APPEAL SUMMARY

Appeal ID: 20420	Project Address: 5060 N Greeley Ave
Hearing Date: 5/22/19	Appellant Name: George-Michael Rusch
Case No.: B-010	Appellant Phone: 503 946 5908
Appeal Type: Building	Plans Examiner/Inspector: Brian McCall
Project Type: commercial	Stories: 4 Occupancy: A-2 A-3 Construction Type: III-A
Building/Business Name: adidas	Fire Sprinklers: Yes - Throughout
Appeal Involves: Erection of a new structure	LUR or Permit Application No.: 18-279416-CO
Plan Submitted Option: pdf [File 1] [File 2] [File 3] [File 4]	Proposed use: Gymnasium

1: Alternate 1 hour fire rated HSS beam assembly with engineering analysis: Granted as proposed.

2. Alternate 1 hour fire rated steel plate assemblies with engineering analysis: Granted as proposed.

Design No. N501

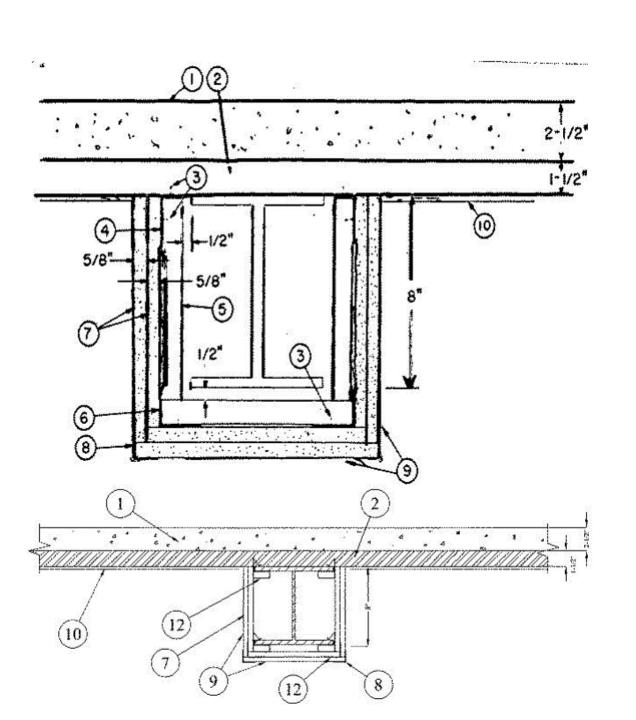
Proposed Design	The proposed design consists of 5 ½" X 5 ½" X 3/8" HSS beam supporting the roof, which includes 5 ply CLT, polyiso insulation, and cover board with PV waterproofing membrane. The beam will be encased with two layers of Type X gypsum board. The HSS beam will be fire caulked at the joints to the CLT member. These members are considered as primary structure. Per 2014 OSSC Table 601, primary structural members for Type IIIA construction are required to be encapsulated for a minimum 1-hour fire-resistance. The beams will be exposed to fire from below and the assembly will require protection from three exposed sides. Please refer to the attached Engineering Judgement Report, stamped by an Oregon licensed fire protection engineer, for more details.
Reason for alternative	The HSS beam is required to have a 1-hour fire rating per Table 601 of the OSSC. UL tested assemblies are not available to define this unique condition, hence the appeal. Code Unlimited has reviewed the proposed design using the component additive method and comparison against the 2-hour tested beam, UL N501, as permitted by OSSC §703.3. The proposed member W/D ratio is greater than the tested beam W/D ratio, which implies a greater inherent fire-resistance. The HSS beam is protected with 2 layers of 5/8" Type X gypsum board, equivalent application of gypsum boards in the 2-hour tested assembly, to provide a minimum 1-hour fire-resistance. Therefore, the proposed design for the HSS beam encased within the gypsum board assembly will exceed the required minimum 1-hour fire-resistance as compared and detailed in the attached report with the tested assembly UL N501. Hence, we urge you to approve this appeal.

Adequate testing is not available for a 1-hour assembly. Therefore, the proposed design is compared to the 2-hour W8x24 beam tested in UL N501,.

Additionally, UL test N501 was also considered to compare the protection provided by the gypsum board for the HSS beam. The proposed HSS beam fire protection is compared to the tested beam using the W/D ratio. The proposed W/D ratio (1.40) is higher than the tested W/D ratio (0.704) due to the limited heated perimeter and greater steel mass. Additionally, UL N501 is tested for 2-hour fire-resistance rating. Therefore, the proposed two layers of 5/8" Type X gypsum board encasing the HSS beam provides near equivalency to the UL assembly to ensure a minimum of 1-hour fire-resistance is provided.

Figure 1: Proposed connection of glulam girders and HSS column using steel plates as shown.

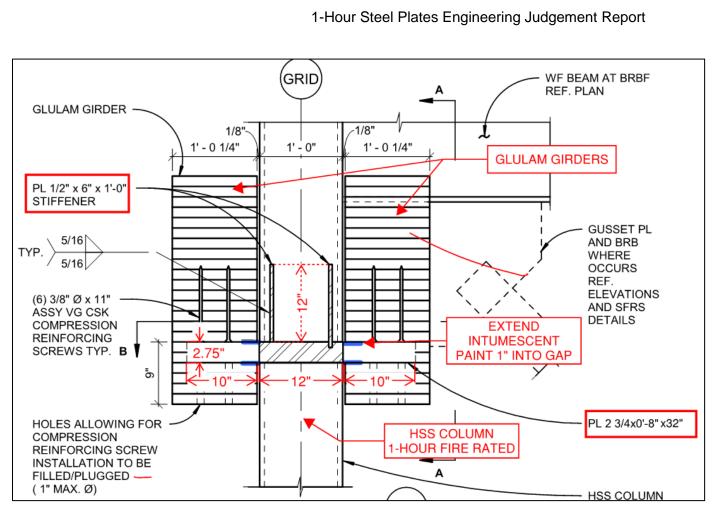
The proposed design consists of two (2) glulam girders connected to a 1-hour fire rated HSS column through a 2.75" steel plate and two (2) 0.5" thick steel stiffeners. The 2.75"x8"x32" steel plate is adjacent to the HSS column. The two (2) 0.5"x6"x12" steel plate stiffeners are welded on the HSS column and the 2.75" thick steel plate. The exposed sides of the steel plates are protected with 0.047" of intumescent paint to provide 1-hour fire-resistance as compared with UL N635. The intumescent coating extends 1" into the penetration of the glulam girders to provide complete protection of the gap.
The steel plates are required to have a 1-hour fire rating to provide continuous protection of the fire-resistance of the HSS column. UL tested assemblies are not available to define this unique condition, hence the appeal.
Code Unlimited has reviewed the proposed design against the tested beam, UL N635, as permitted by OSSC §703.3. The proposed W/D ratio is greater than the tested W/D ratio, which implies a greater inherent fire-resistance. The steel plates are protected with 0.047" intumescent

The proposed design consists of two (2) glulam girders connected to a 1-hour fire rated HSS column through a 2.75" steel plate and two (2) 0.5" thick steel stiffeners. The 2.75"x8"x32" steel plate is adjacent to the HSS column. The two (2) 0.5"x6"x12" steel plate stiffeners are welded on the HSS column and the 2.75" thick steel plate (Figures 1 and 2). The exposed sides of the steel plates are protected with 0.047" of intumescent paint to provide 1-hour fire-resistance as compared with UL N635. The intumescent coating extends 1" into the penetration of the glulam girders to provide complete protection of the gap.

It is important to ensure the gap between the wood and the steel plate is protected. Overlap the intumescent paint 1" onto the wood member or as an alternate extend the paint 1" into the wood/ steel gap (See note on Figure 1)
